Local Planning Panel

Address: 1 Onslow Place, Elizabeth Bay

Application: D/2025/89

- Amending development application to D/2022/456 which approved a residential flat building with 2 basement levels
- Amending DA seeks consent for additional private open space to Unit 6 on Level 7 rooftop, comprising plunge pool / spa and outdoor terraced area

Privacy

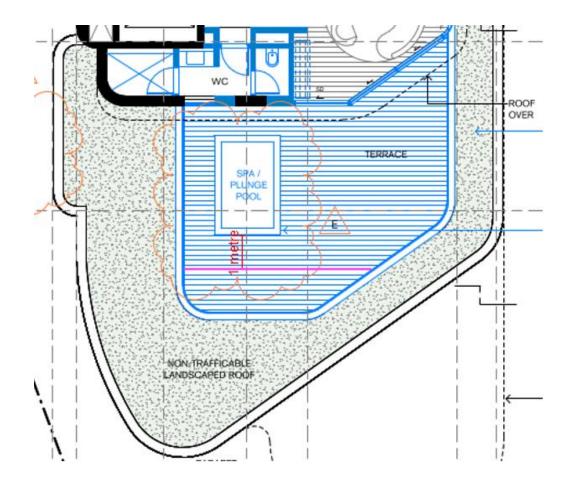
- proposal does not achieve min. 9m building separation distance specified in Part 3F of the ADG
- trafficable roof terrace approx. 5m from the SW boundary and the pool / spa is approx. 7m from this boundary

condition
recommended
requiring trafficable
terrace reduced to
achieve acceptable
visual privacy for 3
Onslow Place

- Design modification condition for trafficable terrace to ensure acceptable visual privacy for neighbouring properties is achieved
- Condition requiring plant equipment to be located wholly within the frame of the proposed pool/spa to manage visual impacts
- Standard conditions for swimming pools

view from bedroom balcony – Unit 61, 3 Onslow Place / 36A Macleay Street

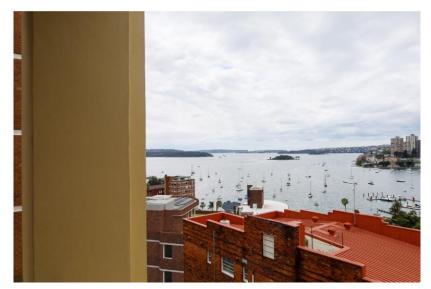
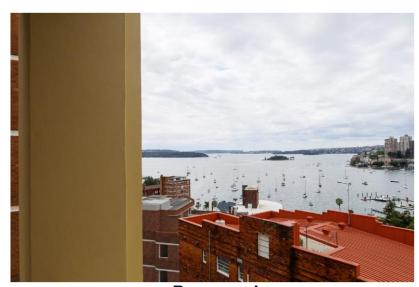
- proposal is under maximum LEP height limit
- iconic water views of Sydney Harbour are obtained from viewpoints at neighbouring properties
- a Visual Impact Assessment has been prepared which assesses the impact on 19 viewpoints
- assessment demonstrates the proposal will not result in unreasonable view loss
